# SERVICE BULLETIN

SB No. **81** Issue No. **1**
**TITLE** INSPECTION AND REPLACEMENT OF ALUMINIUM HINGE ON INJECTOR AIR INTAKE DUCT AUXILIARY INTAKE DOOR

T67M260-T3A.

FIG 1

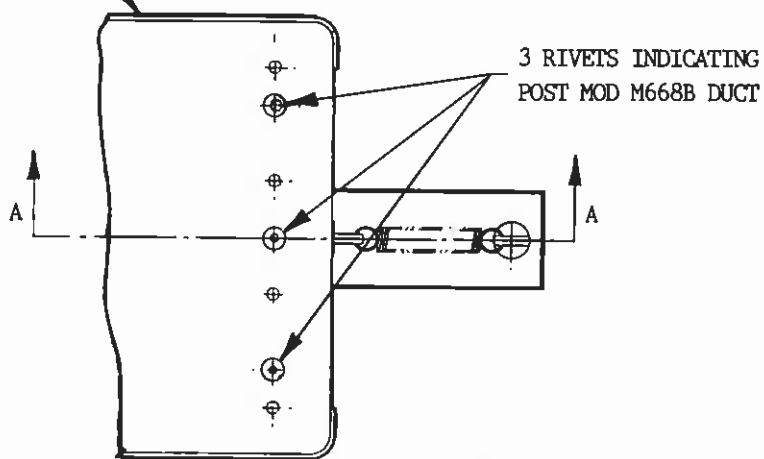
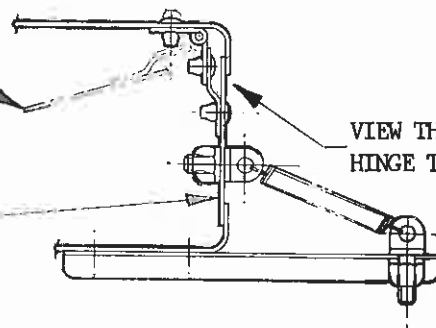
1. Establish Mod state of intake duct. This is achieved by either:
  - a) For Post Mod M668A (New Build) deflecting door fully open until hinge can be seen. Its colour should be bright for stainless steel.
  - b) For Post Mod M668B (repaired) top of duct at hinge position should show 3 'pop' rivet heads, Ref. Fig. 1.
  - c) Pre Mod M668A or B, aluminium hinge indicated by its pale mustard colour.
2. If it is established that Mod M668A or B is incorporated, then annotate in log book SB 81 complied with. If intake duct is Pre Mod M668A or B, then proceed as paragraph 3.

- 3 Inspect aluminium hinge for thinning of the hinge knuckles.
  - i) If hinge is worn or broken, then replace air intake duct with Post Mod M668A or B, item ref paragraph 5.
  - ii) If hinge is satisfactory check every 50 flying hours until Mod M668A or B is incorporated.
4. Return Pre Mod M668 intake ducts to manufacturer for repair to Post Mod M668B standard in accordance with Drawing No. T67G-03-047.
5. Fit new or repaired air intake duct T67G-50-103 Post Mod M668A or Mod M668B, and annotate log book SB 81 complied with.
